Service Bulletin No. 433B

MODEL	J4500 Series	TYPE	Field Change Program	SECTION/GROUP	3-Body	DATE	July 21, 2016
SUBJECT	WINDOW MOUNTING HARDWARE						
CONDITIONS

Ref. MCI NHTSA Recall No.:16V-510

Figure 1. Non-egress window bracket rework locations only.

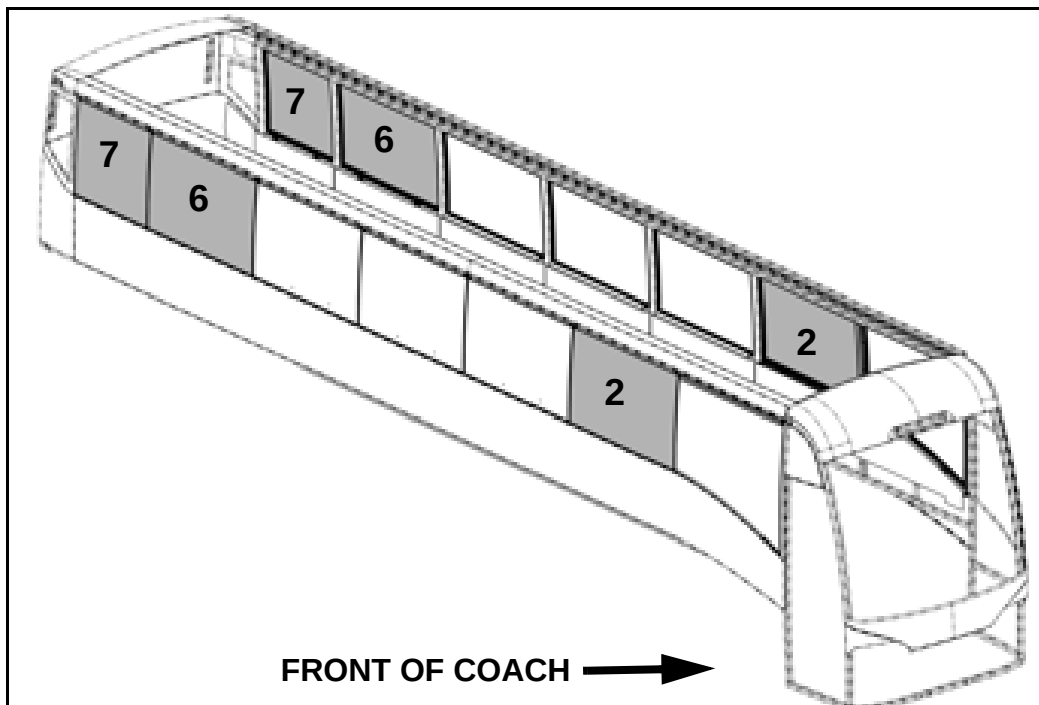
The outlined procedure steps in this bulletin are applicable only to the #2, #6 and #7 non-egress windows on both the curbside and roadside of the coach (refer to Figure 1 for designated locations).

If the coach is equipped with a wheelchair lift, the curbside #7 window brackets do not require rework.

Figure 4.

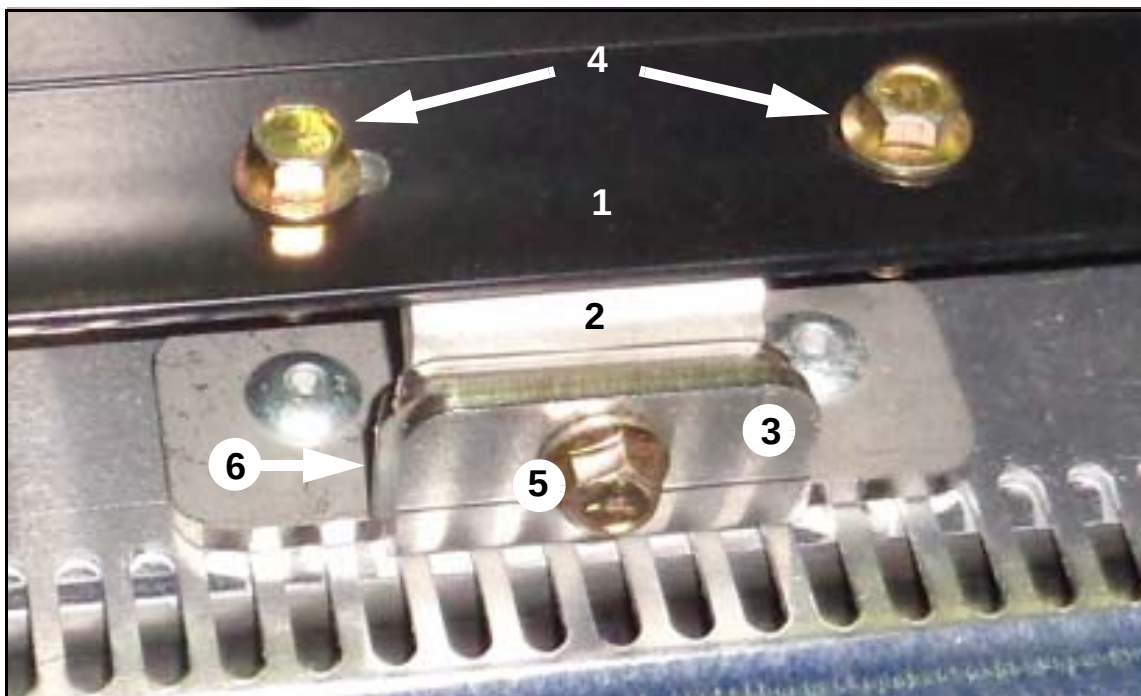
6. Locate one of two sets of mounting hardware (Items 4 and 5 / Figure 4) securing the window to the upper and lower mounting brackets.

If a horizontal mounting capscrew (Item 5 / Figure 4) is missing, a new capscrew and eight (8) shims will need to be ordered for the bracket rework.

- c. Adjust the alignment of the rework window so that the two (2) adjacent window edge profiles are flush against the straight edge. Hold in position and add the necessary shims (0 to 4 shims) to fill the gap between the lower mounting bracket and horizontal capscrew (Items 3 and 5 in Figure 4).***

7. Loosen off, but do not remove, the horizontal bolt shown in Figures 4 and 6.

Remove, add Loctite and re-install one (1) vertical bolt (Item 4 / Figure 4) at a time to ensure exterior window symmetrical alignment.

8. Remove one (1) vertical bolt (Item 4 / Figure 4). Apply blue Loctite 243 to the threads and re-install. Position a wrench on the nut and torque the bolt to 8-10 ft-lbs.
9. Remove the remaining vertical bolt. Apply blue Loctite 243 to the threads and re-install. Position a wrench on the nut and torque the bolt to 8-10 ft-lbs.

If installation contains shims, ensure that the shims are oriented completely vertical with no gaps therein.

If so equipped, all existing production shims must be re-installed to avoid window frame stress damage.

10. Remove the horizontal bolt and shims (if applicable). Apply blue Loctite 243 to the threads. Orient the shims on the bolt and re-install. Torque the bolt to 8-10 ft-lbs.
11. Repeat Steps 6 to 10 to the other set of mounting hardware on the window.

Figure 5.

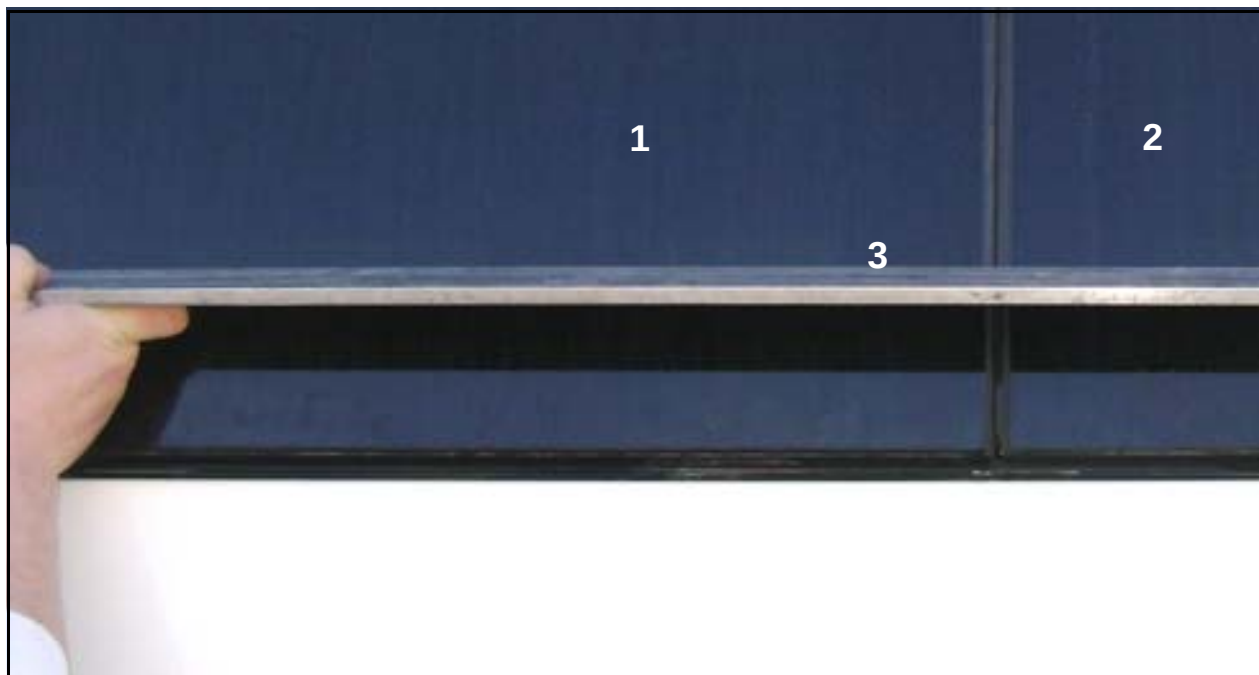
- a. In front of the rework window, position one (1) person on a ladder outside the coach and another in the coach cabin,***
- b. Outside the coach, position a cloth-covered straight edge across the rework window and the next adjacent window (refer to Figure 5),***
